CITY OF JOPLIN
ADDENDUM NUMBER 2

Date: 1/10/2020

Project Name: **City of Joplin Trail and Pedestrian Bridge STP-3201(705)**

COLUMN DETAIL

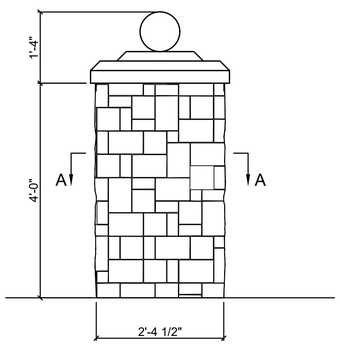
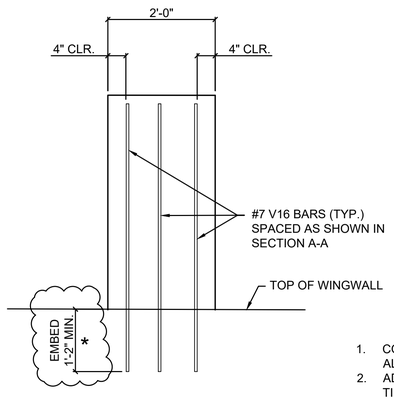
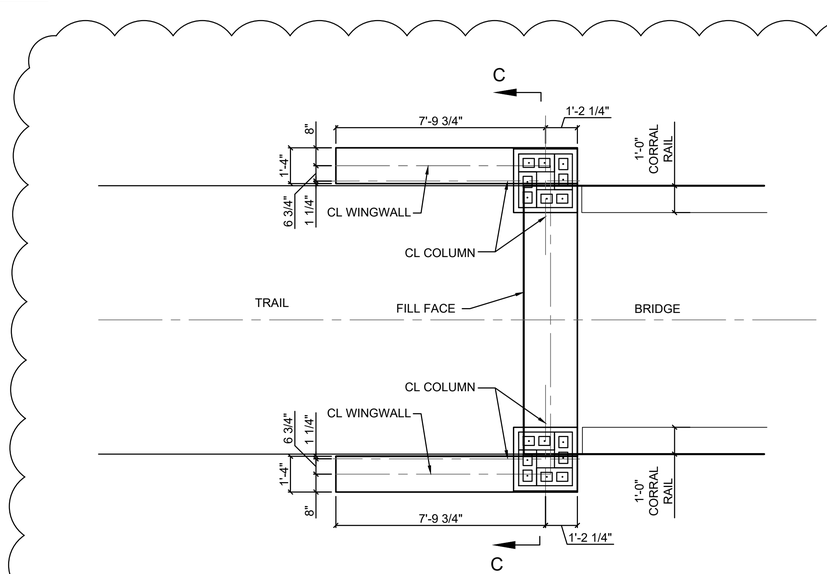
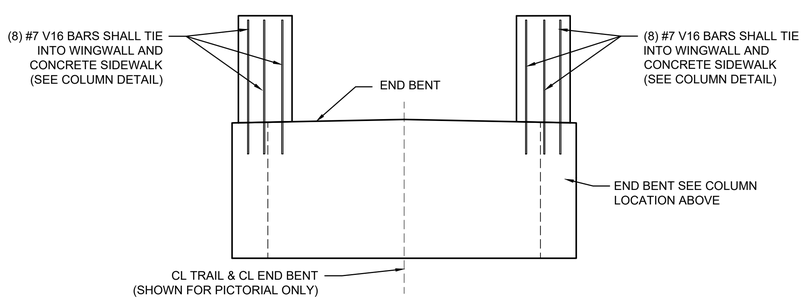
5) **CLARIFICATION ITEMS:**
   1. The asphalt pavement for the trail shall be constructed with Bituminous Pavement Mixture BP-2 for the full 3" depth. The bid form has been revised to reflect this change. The price for the BP-2 asphalt shall include the application of a prime coat on the aggregate base, per City of Joplin Standard Specifications.
   2. The bid form includes two new bid items for the Removal and Backfill of Unsuitable Material, to be performed in accordance with City of Joplin Standard Specifications, if encountered.
   3. Multiple bridge plan sheets have been revised to include the addition of a modified concrete corral rail with pipe rails. The location of the stone veneer columns at the corners of the bridge has been revised as well.
